World Forum for Harmonization of Vehicle Regulations**Working Party on General Safety Provisions****122nd session**

UN Regulation No. 34 (Prevention of fire risk)**Proposal for Supplement 3 to the 03 series of amendments of
UN Regulation No. 34****Submitted by the expert from the International Organization of Motor
Vehicle Manufacturers ***

"Model B
(See paragraph 3.1.5. of this Regulation)

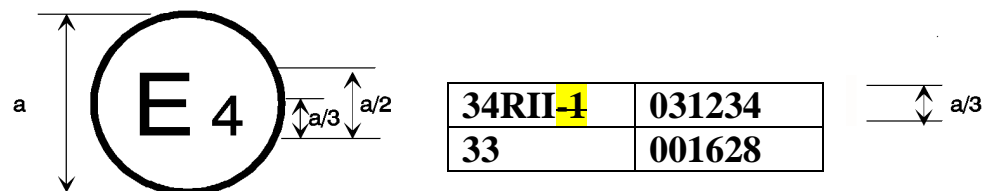
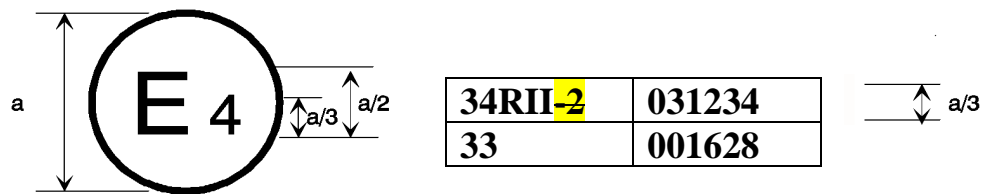
Annex 2, amend to read (changes highlighted in yellow – footnote unchanged):

The above approval mark affixed to a vehicle shows that the type concerned was approved in the Netherlands (E 4) pursuant to Regulations Nos. 34 Parts I or IV and II-1 and 33.* The approval numbers indicated that, at the date when the respective approvals were given,

The above approval mark affixed to a vehicle shows that the type concerned was approved in the Netherlands (E 4) pursuant to Regulations Nos. 34 Parts I or IV and II-2 and 33.* The approval numbers indicated that, at the date when the respective approvals were given, ...”
